SITE DEVELOPMENT PLAN AMENDMENT NO.1 CALVARY CHAPEL

THIS AMENDMENT TO THE CALVARY CHAPEL SITE DEVELOPMENT PLAN IS NEEDED DUE TO REVISION TO THE LANDSCAPE PLAN AS A RESULT OF DISTURBANCE IN THE PREVIOUSLY DESIGNATED NON-DISTURBANCE AREA.

SITE DEVELOPMENT PLAN AMENDMENT NO. 1
CALVARY CHAPEL
TOWN OF CASTLE ROCK PROJECT NO. SDP22-0022

SITE DEVELOPMENT PLAN
COVER SHEET 1 of 4
04/21/2022

CONCEPTUAL LANDSCAPE PLAN
SHEET 4 of 4

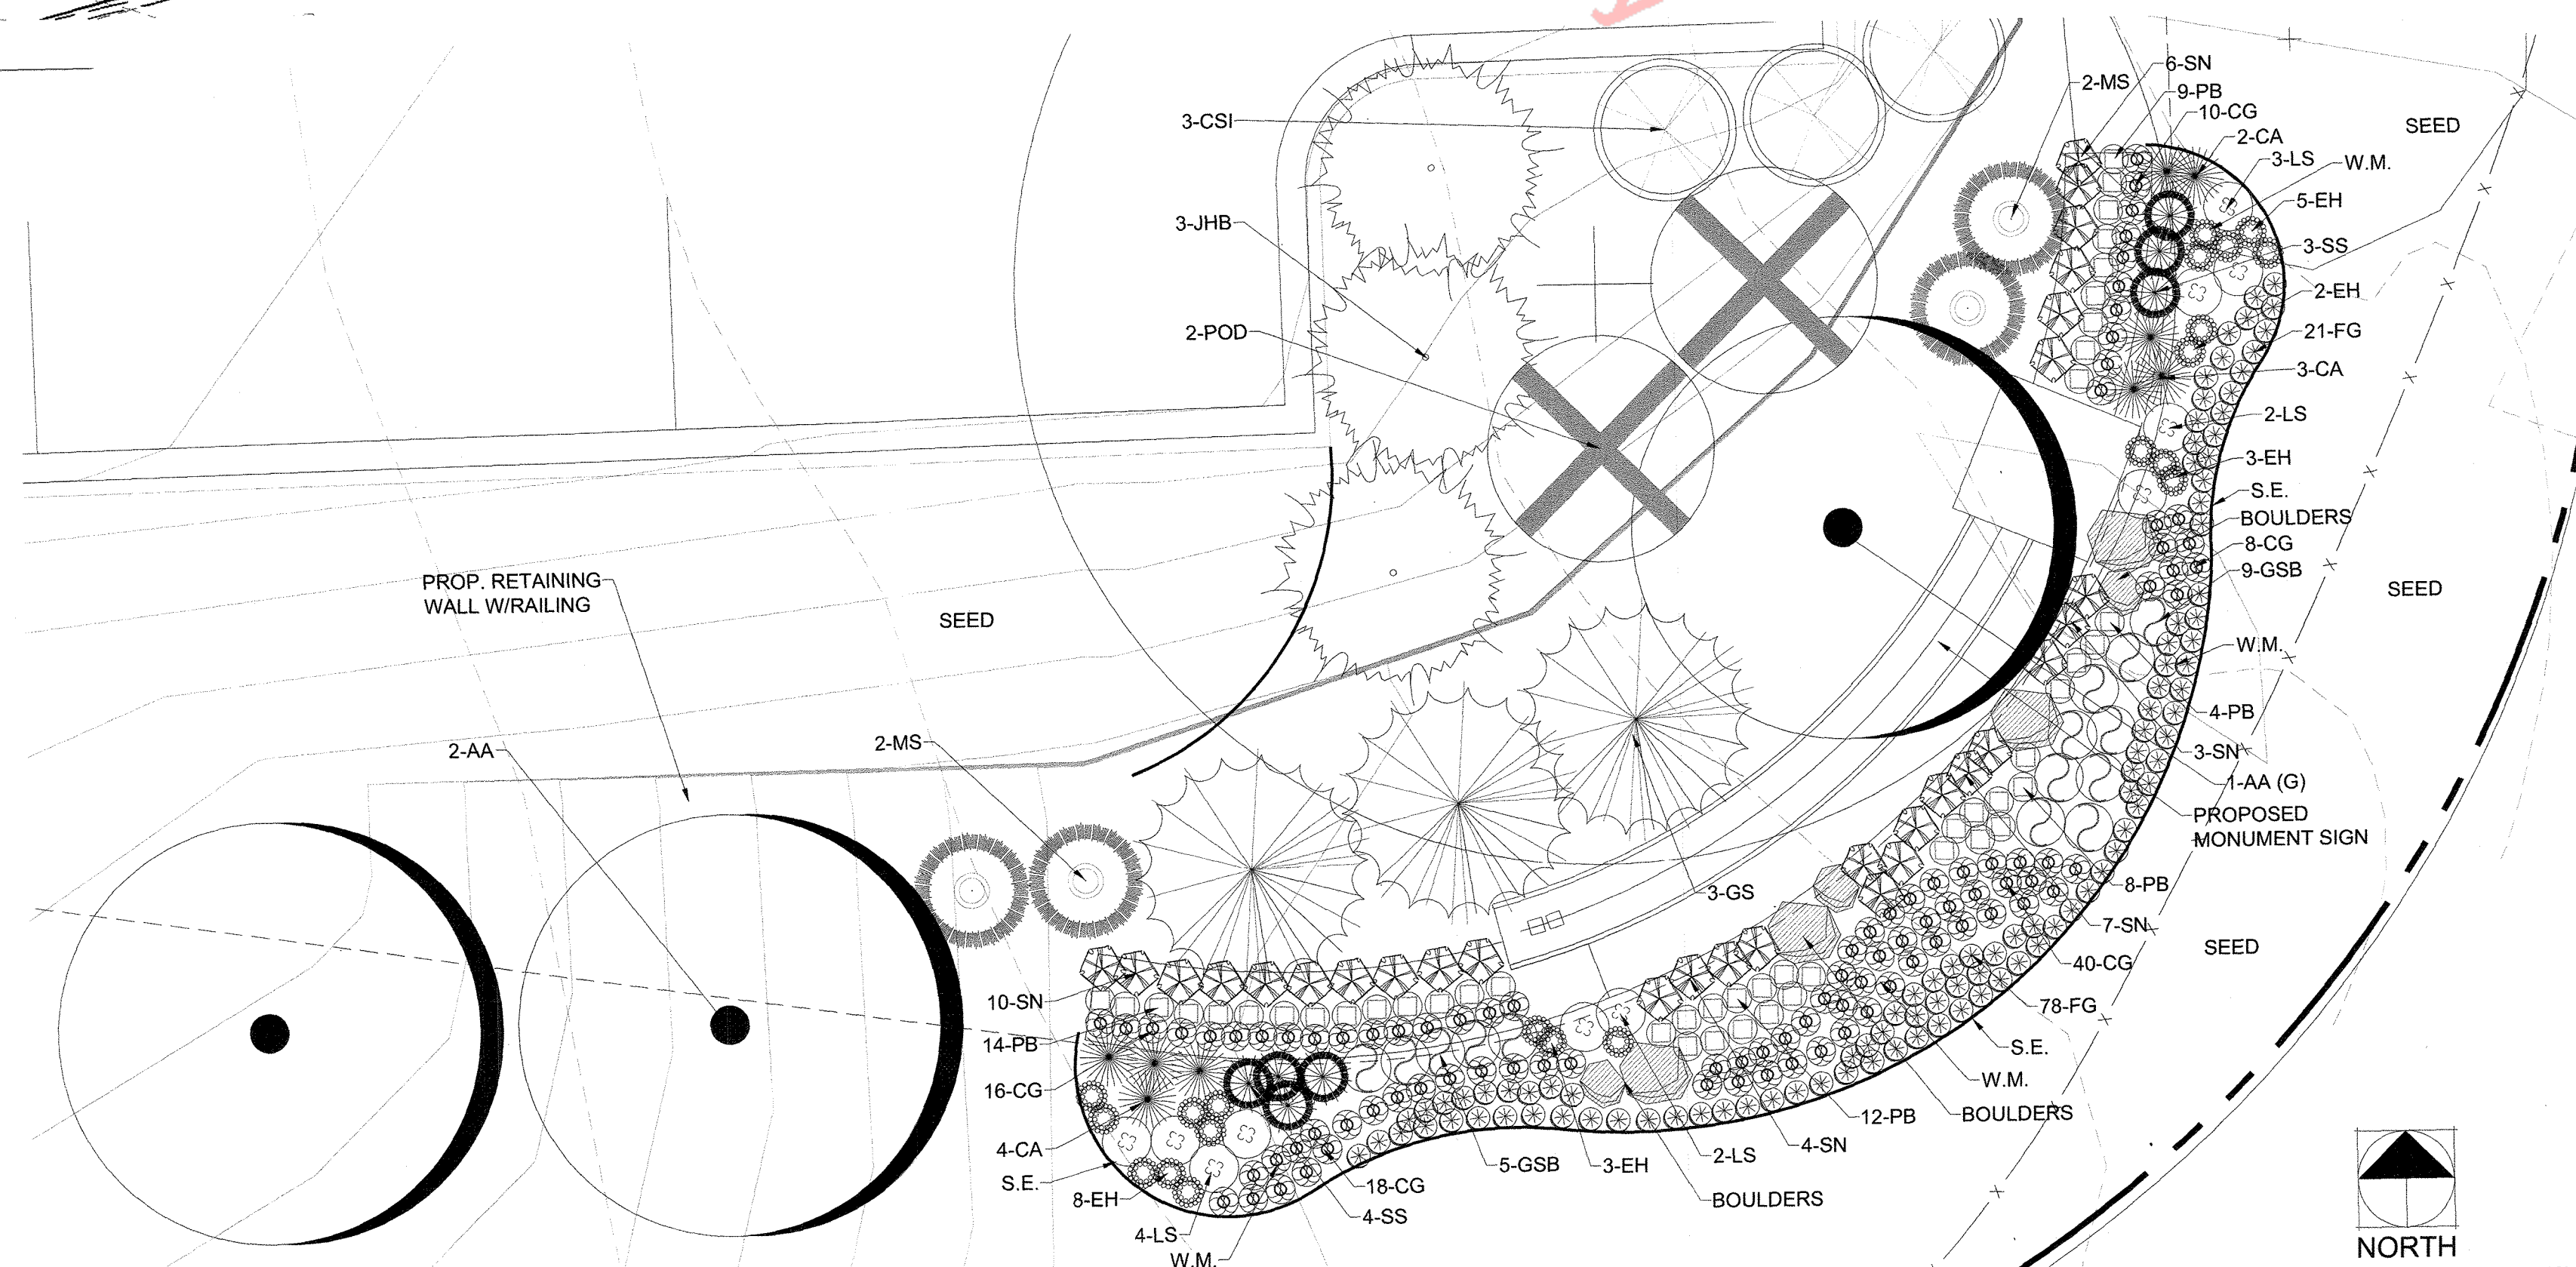
EXISTING VEGETATION ALONG THE NORTH BUFFER WAS ORIGINALLY CALLED OUT TO BE PROTECTED AND PRESERVED IN PLACE. THROUGH THE CONSTRUCTION PROCESS, SOME OF THIS VEGETATION WAS REMOVED. THIS AMENDED SDP ADDRESSES THIS NORTH BUFFER AREA AND ADDS LANDSCAPE IN PLACE OF THE REMOVED VEGETATION.
